ADDENDUM # 1

IFB # V-1679 – Bus Operator Safety Barrier

January 25, 2017

Appendix B: Revised Drawings for 1800 Series Buses

ENTRANCE VIEW

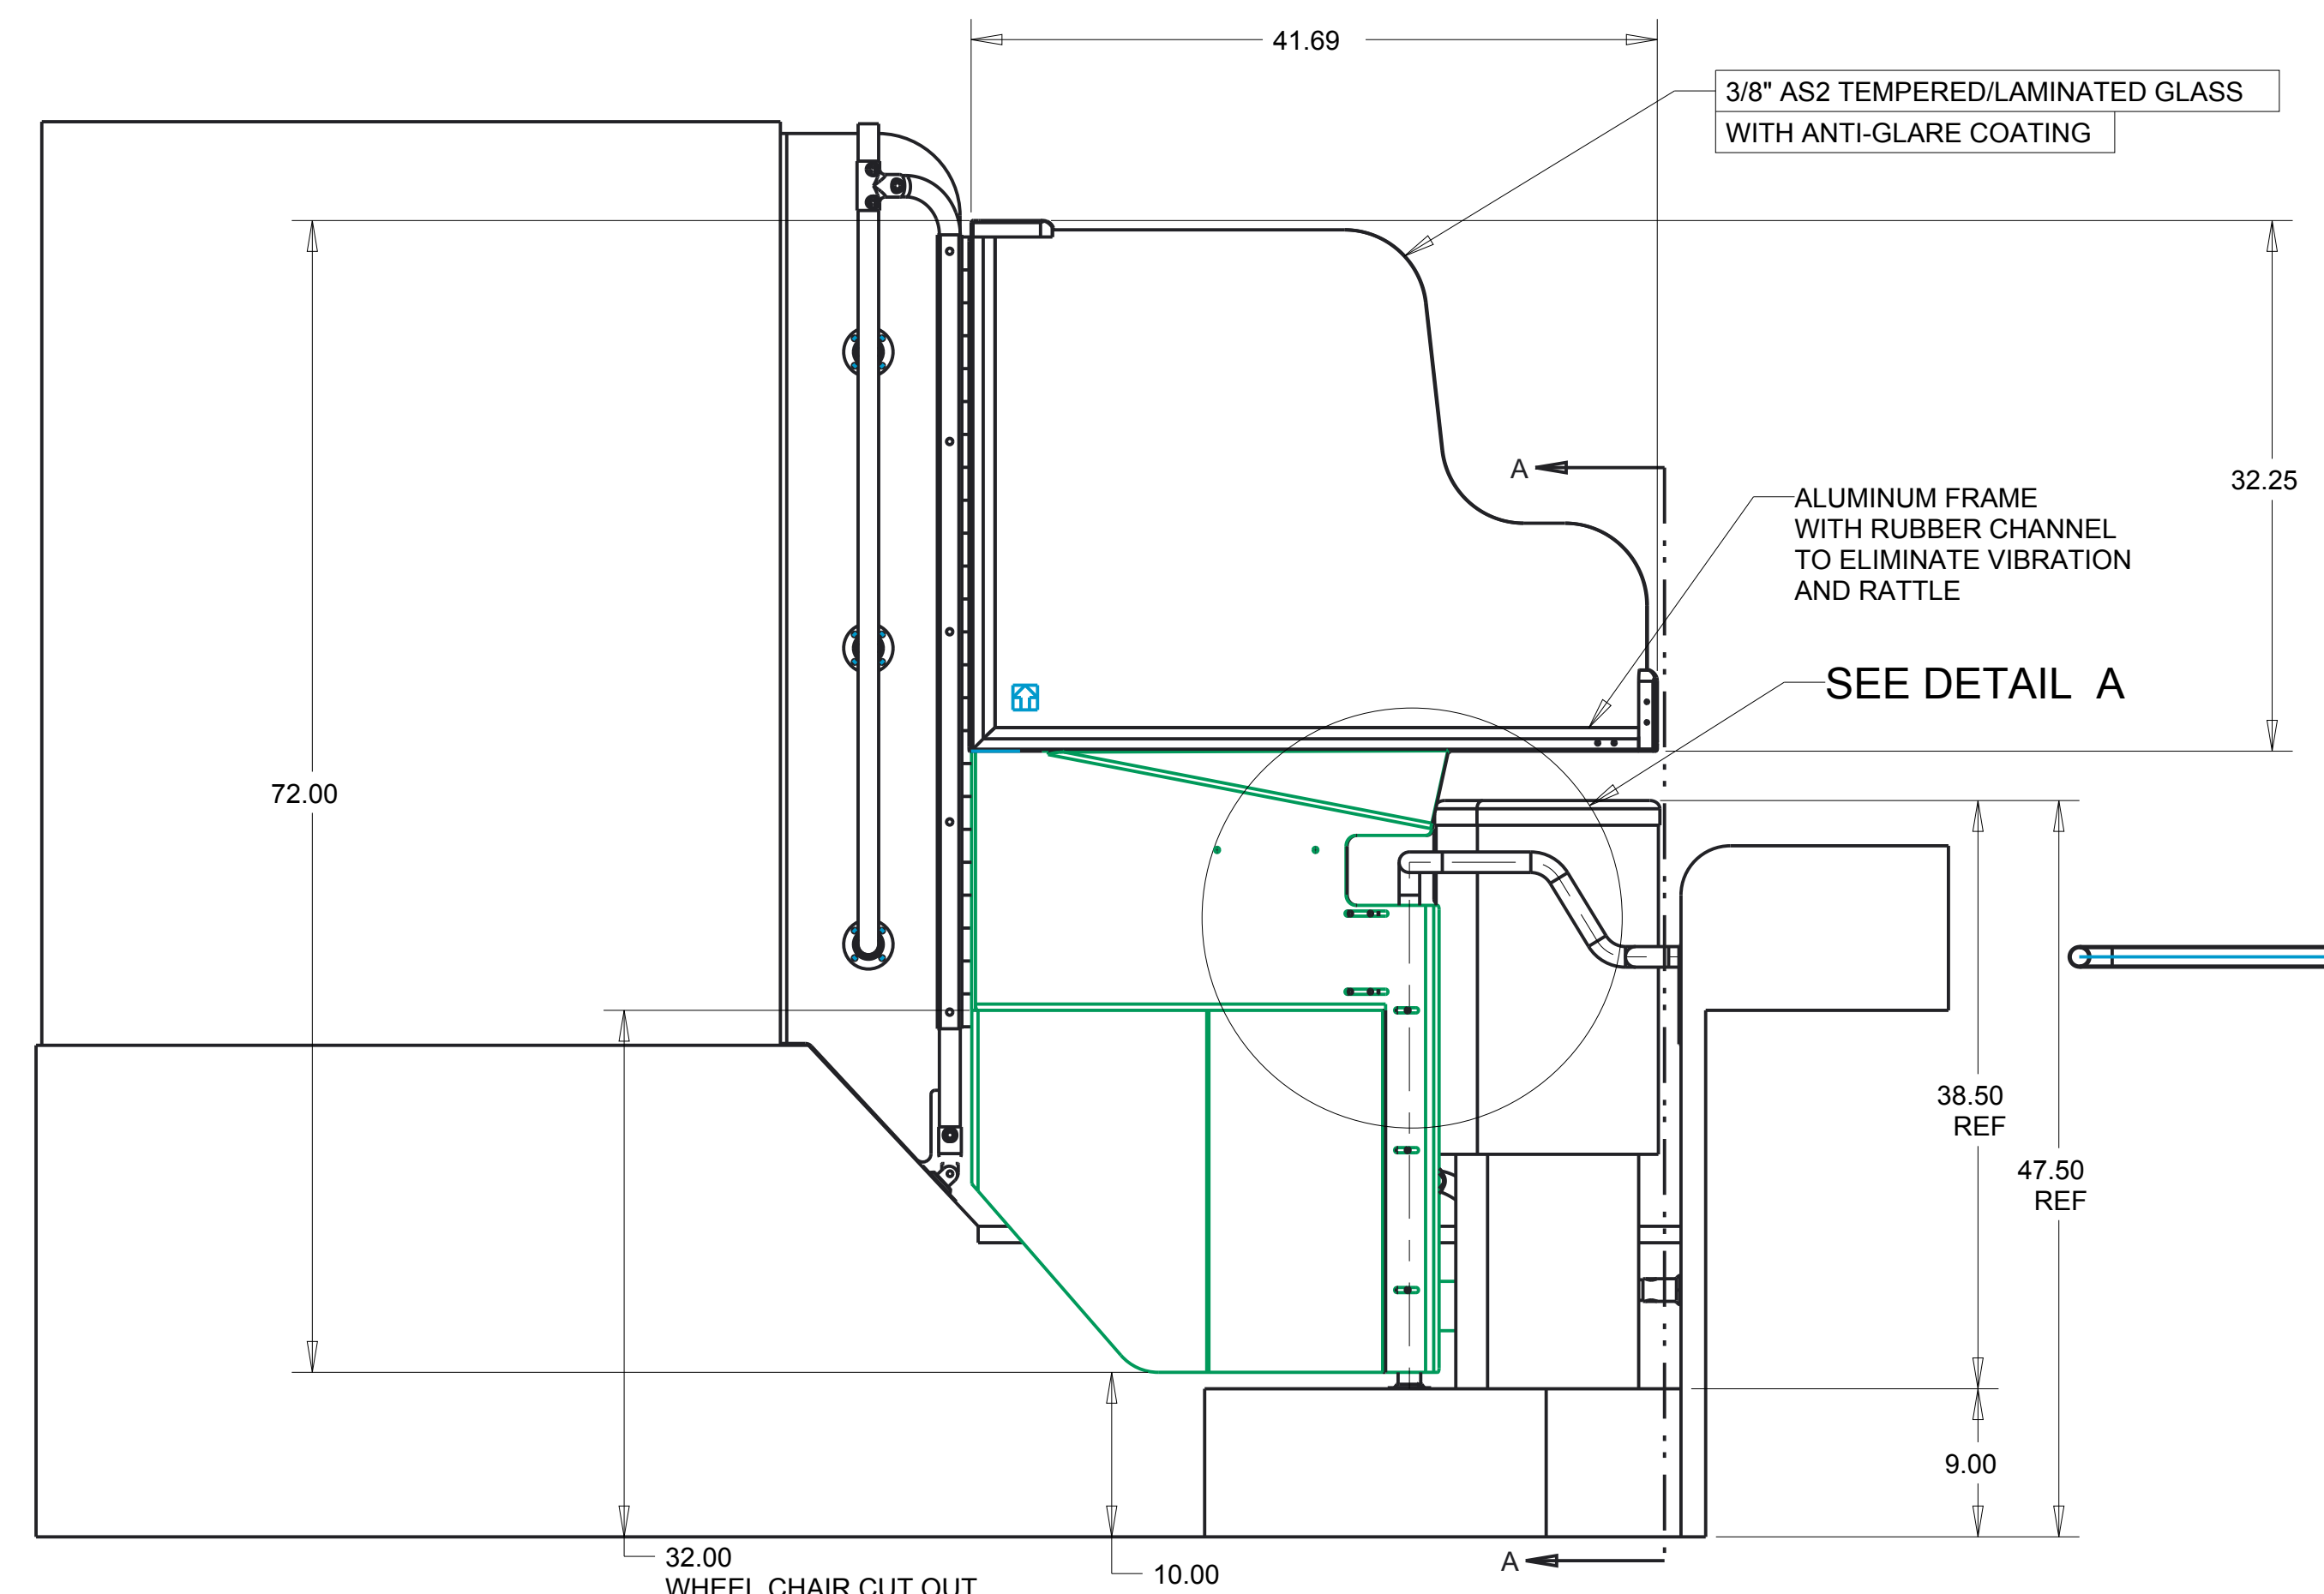
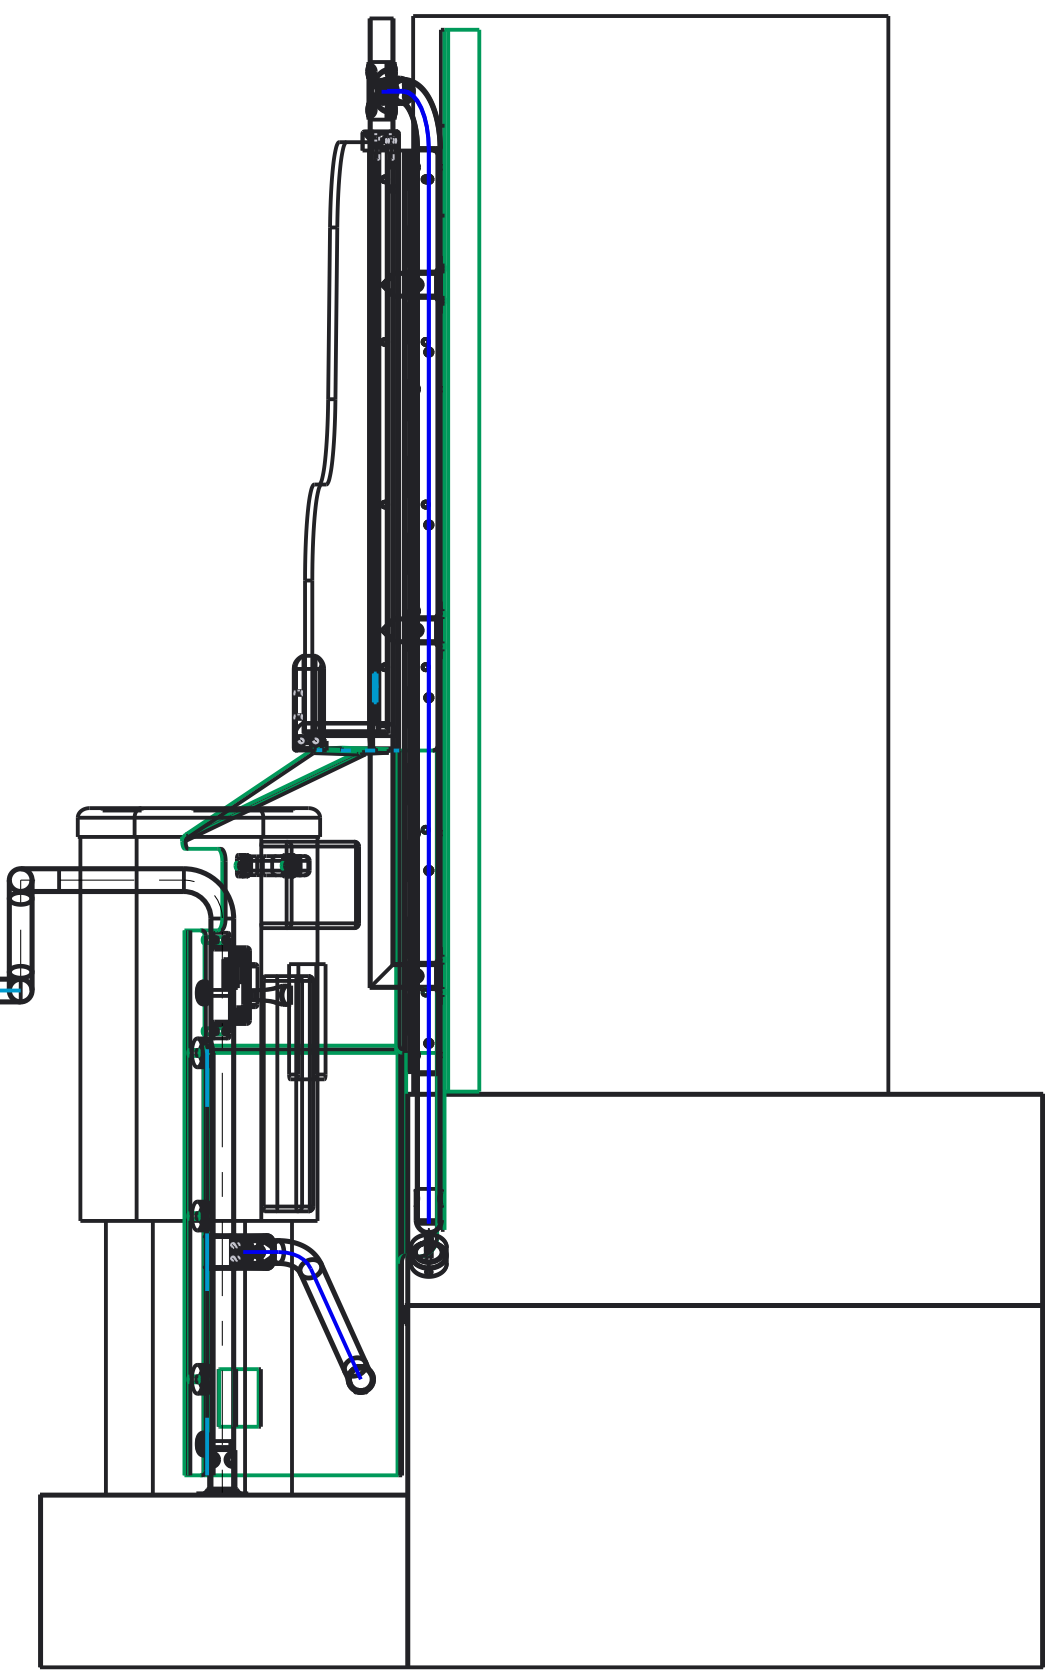
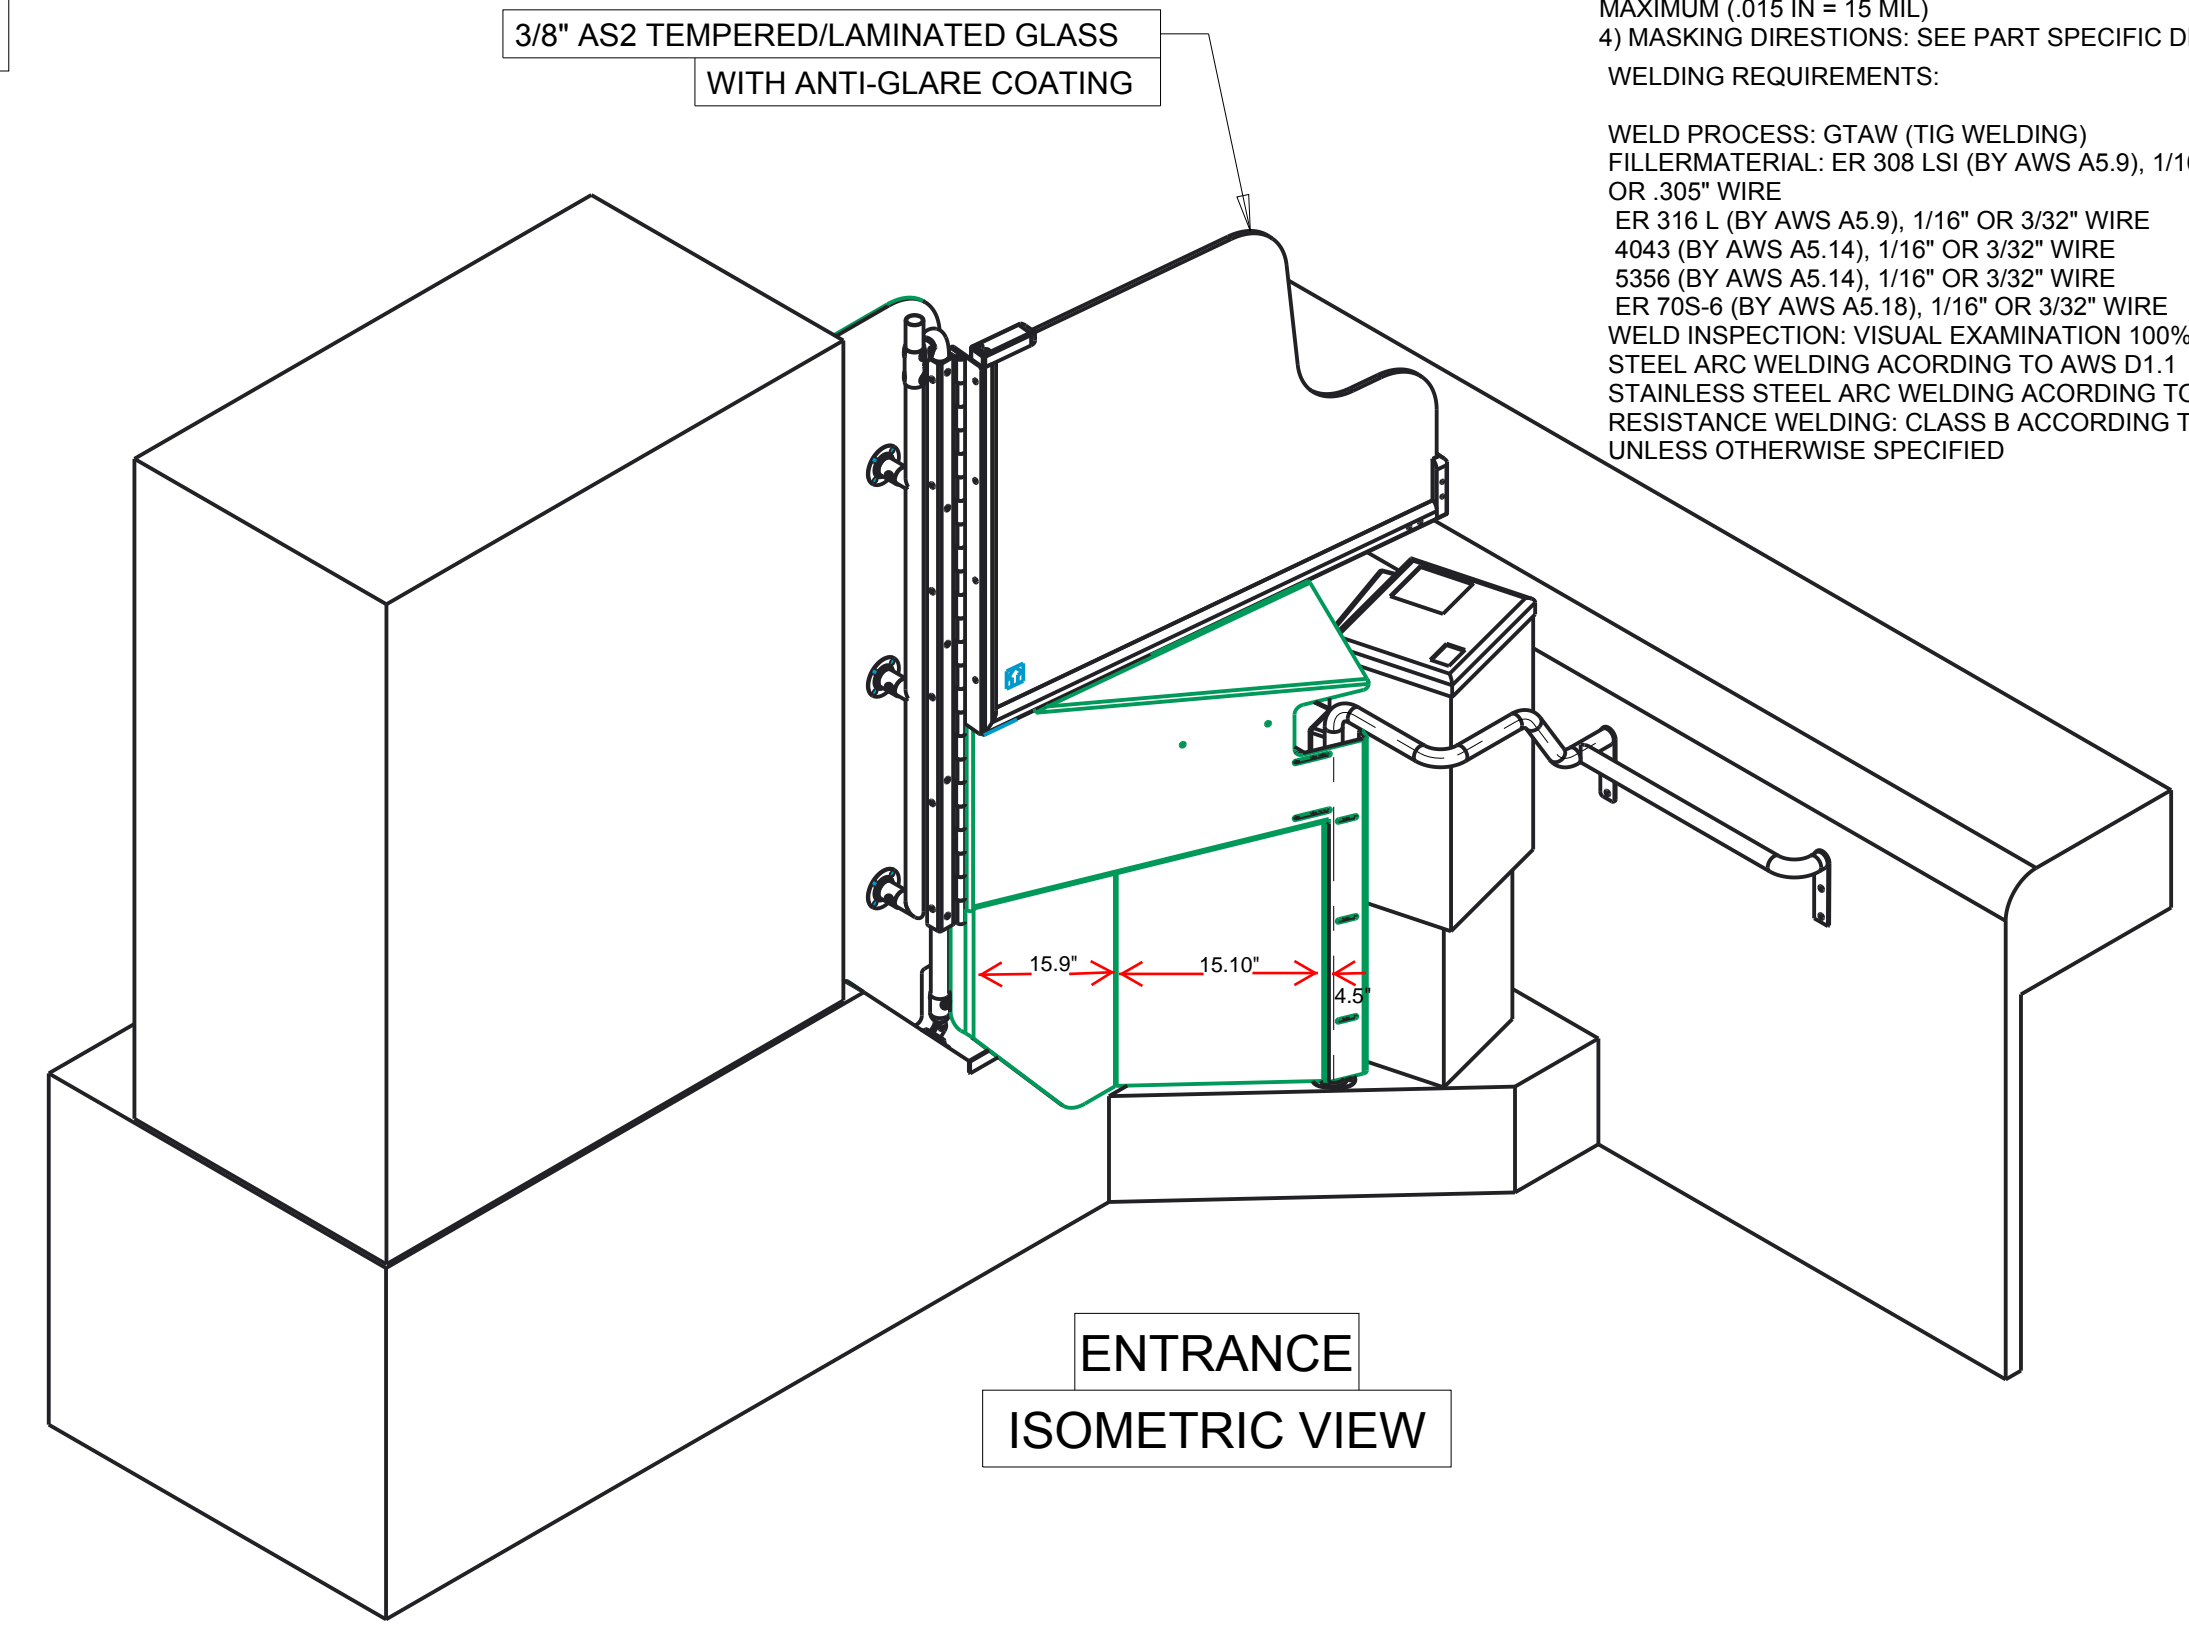
Drawings are revised to include dimensions of the Bus Operator Safety Barrier for each of the bus series. The drawings are in the following pages.

REVISIONS			
REV	DESCRIPTION	DATE	APPR
-	NOT RELEASED FOR PRODUCTION	08/21/15	NICE
A	ADDED DIMENSIONS	01/24/17	NICE

Answer: Drawings are attached to this addendum.

Appendix B: Drawings for 1700 Series Buses

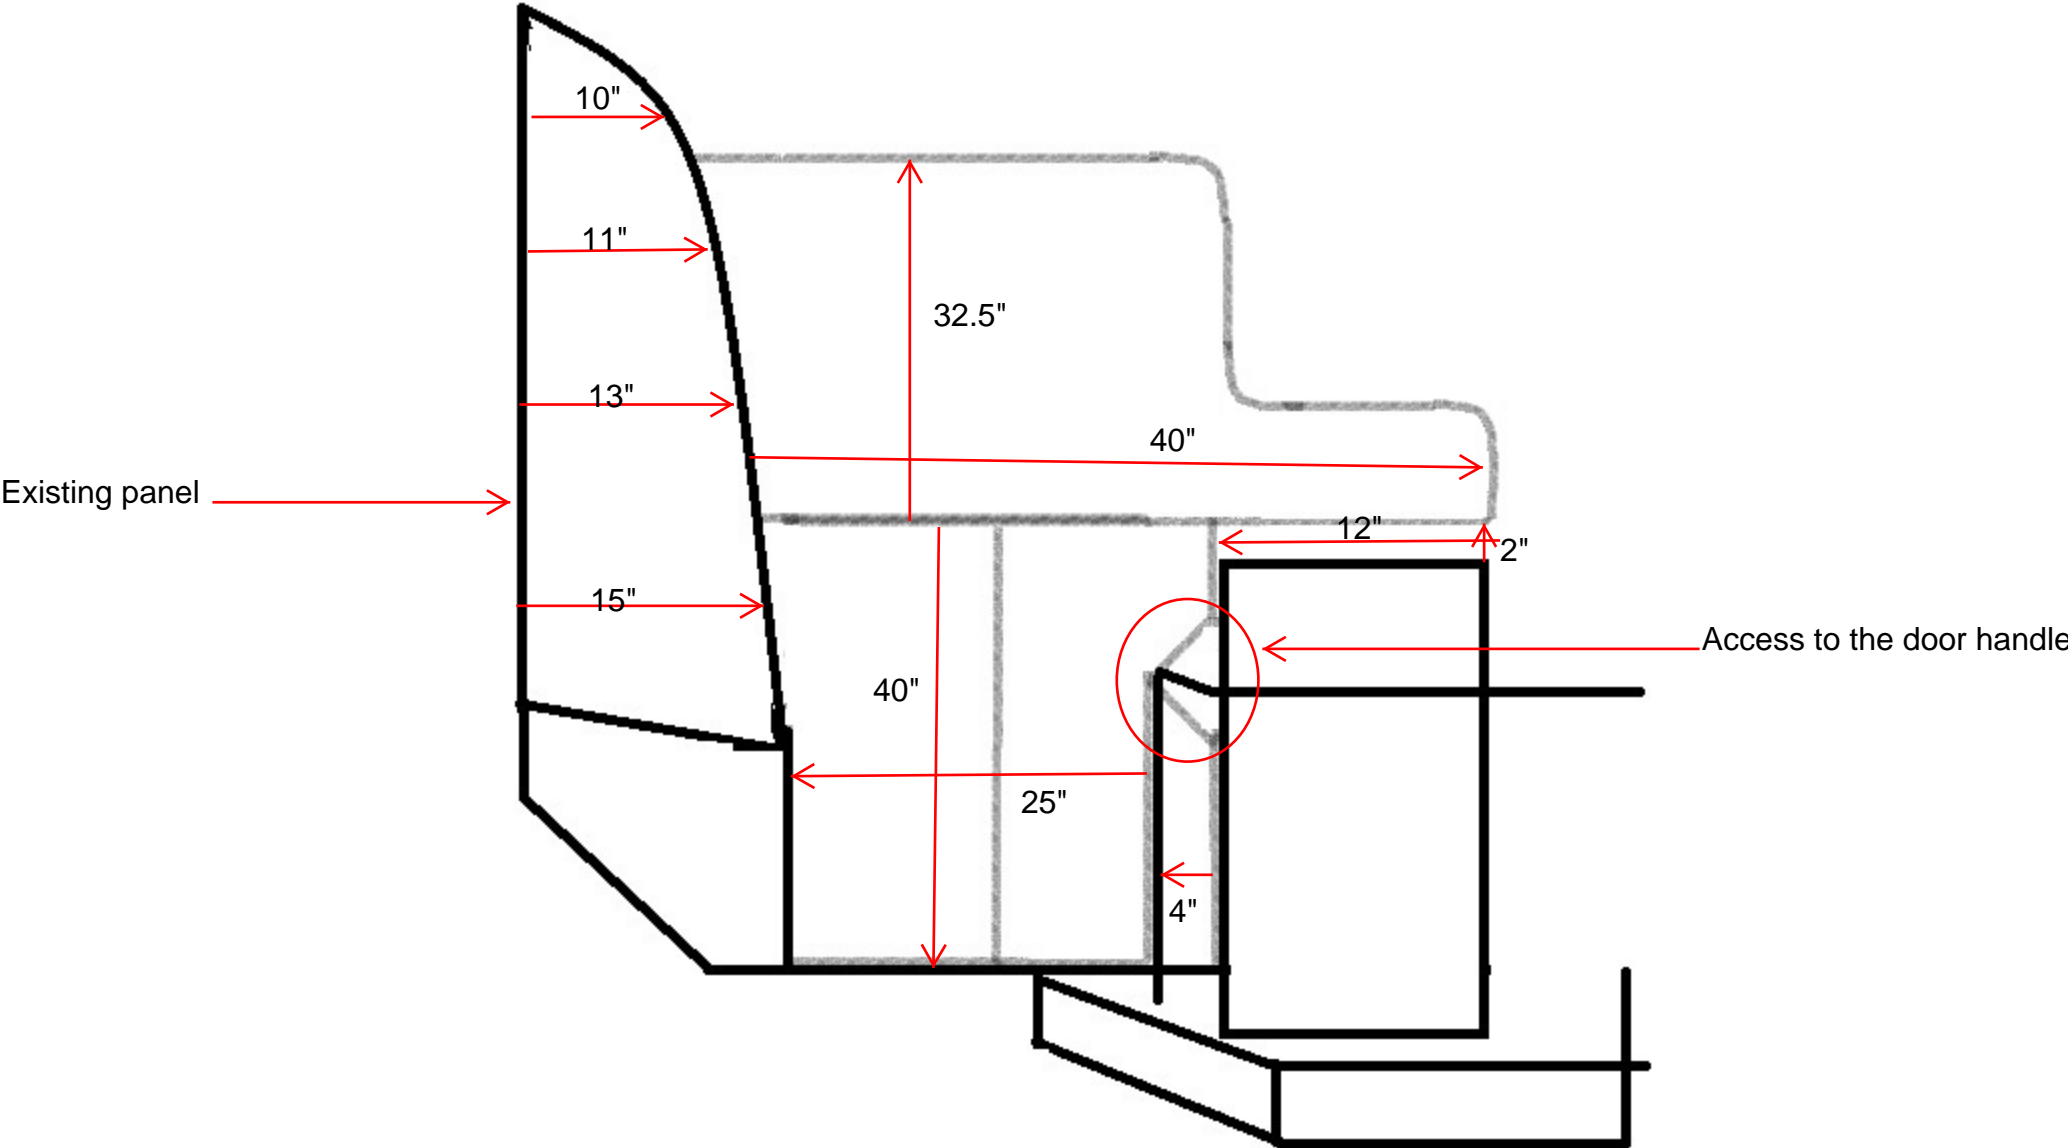
Design of Bus Operator Safety Barrier for 1700 Series of Orion VII buses. Gray/pencil lines indicate the driver barrier. Drawing not to scale. Dimensions are approximate. Actual dimensions may vary. Glass edges must be curved and similar to the design given for 1800 series.
